Service Bulletin

SAFETY RECALL

2003-2004 ST1300/A Ground Connector Cap Replacement

**ST1300/A #1
DECEMBER 2004**

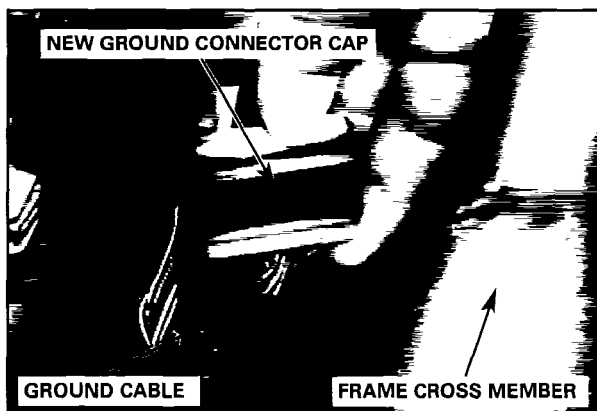
1. Securely connect the new ground cap and route its ground cable rearward, under the frame cross member, and toward the main ground.

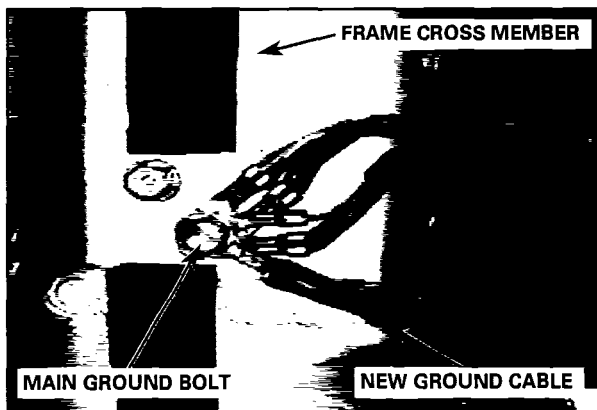
2. Remove the main ground bolt, attach the new cap's ground cable to the bolt, and tighten the bolt.

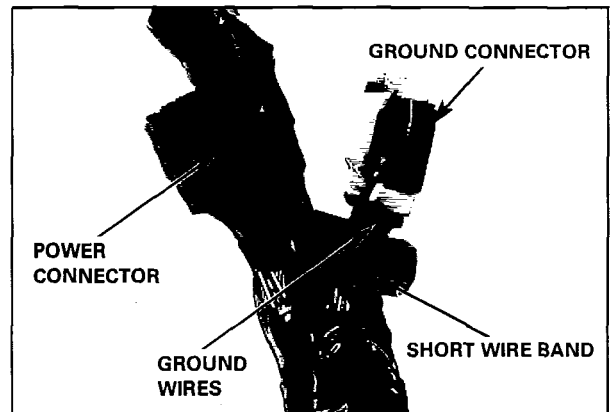
4. Using the small wire band, bind the green ground wires of the ground connector and ground cable of the new connector cap together.

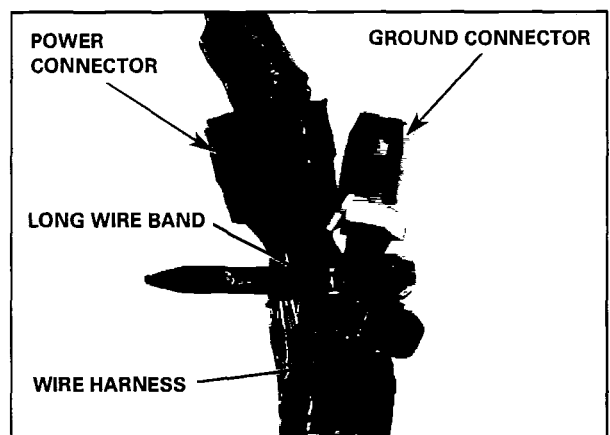
5. Use the large wire band to secure the ground connector, power connector, and wire harness together.
